HALE KIDS SUBDIVISION

Engineering Comments: FINAL PLAT COMMENTS (should be addressed prior to submitting the FINAL PLAT for review and/or signature by the City Engineer):

APPLICATION NUMBER 1 DATE October 15, 2020

APPLICANT Hale Kids Subdivision

DETAIL SITE PLAN

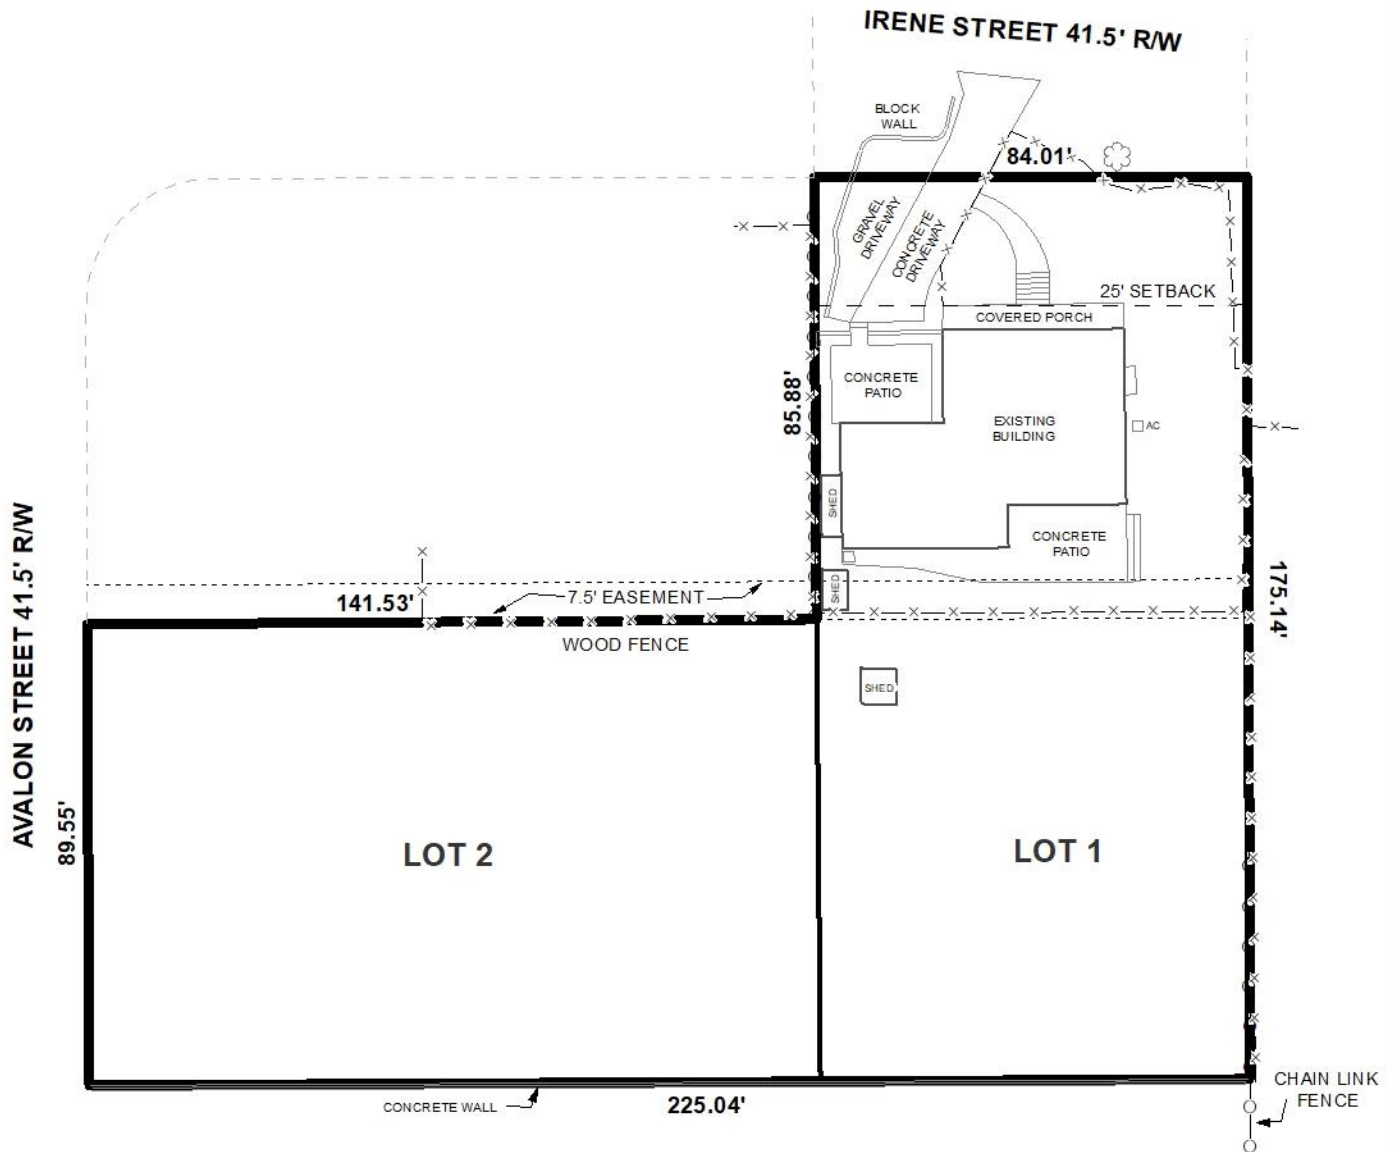
- B. Provide a thicker subdivision boundary line. All the line weights appear to be similar.
- C. Provide the Surveyor's and Owner's (notarized) signatures.

- D. Add a note to the SUBDIVISION PLAT stating that as shown on the 1984 aerial photo (FLIGHT 24 - #73) LOTS 1 and 2 will receive historical credit of existing (1984) impervious area towards stormwater detention requirement per Mobile City Code, Chapter 17, Storm Water Management and Flood Control) as follows: LOT 1 – 2,500 sf and LOT 2 – 2,200 sf.

As proposed, Lot 1 fronts Irene Street and Lot 2 fronts Avalon Street. Both are minor streets without curb and gutter illustrated on the preliminary plat as having substandard right-of-way widths of 41.5 feet. Section V.B.14. of the Subdivision Regulations requires a 60-foot right-of-way width for minor streets not provided with curb and gutter. As such, dedication to provide 30 feet from the centerline of each road would typically be required. However, it should be noted that at its meeting on October 16, 2003 the Planning Commission approved a subdivision request which directly abuts to the East of the subject site requiring dedication only to provide 25 feet from the centerline of Irene Street. This 50-foot right-of-way width is further supported by a previously approved subdivision located 181'± South of the subject site at the corner of Avalon Street and Stillwood Lane West. The Viola E Powe resubdivision was approved in 1968 illustrating a distance of 25 feet to the centerline of Avalon Street. As this is in keeping with the surrounding area, a similar right-of-way width would be recommended for the subject site, and as such, Lot 1 would not require any dedication at this time. However, the preliminary plat does not illustrate the distance to the centerline of Avalon Street from the Western boundary of Lot 2 and dedication to provide 25 feet from the centerline may be necessary. If approved, a waiver of Section V.B.14. of the Subdivision Regulation may appropriate, and the Final Plat should be revised to label the right-of-way width for both Irene Street and Avalon Street adjusted for dedication, as appropriate.

As illustrated, both proposed lots will meet the minimum size requirements of the Subdivision Regulations and as such, the lot size label in both square feet and acres should be retained on the Final Plat or a table should be furnished on the Final Plat providing the same information. It should be noted that the preliminary plat illustrates a front setback for proposed Lot 1, but not proposed Lot 2. As such, the Final Plat should be revised to show a 25-foot minimum building setback along both frontages, adjusted for dedication, if necessary.

A 7.5-foot drainage and utility easement is indicated on the preliminary plat. This should be retained and a note should be placed on the Final Plat stating that no structure may be placed or constructed within any easement without the permission of the easement holder.

- 1) Dedication to provide 25 feet from the centerline of Avalon Street, if applicable;*
- 2) Revision of the Final Plat to label the right-of-way widths for both Irene Street and Avalon Street, adjusted for dedication, as appropriate;*

- 3) Revision of the Final Plat to illustrate a 25-foot minimum building setback for Lot 2 along Avalon Street, adjusted for dedication, if applicable;*

- 4) Retention of the lot size in both square feet and acres, or the furnishing of a table on the Final Plat providing the same information, adjusted for dedication;*

- 5) Retention of the 7.5-foot utility and drainage easement on the Final Plat;*
- 6) Placement of a note on the Final Plat stating that no structure may be constructed or placed within any easement without the permission of the easement holder;*
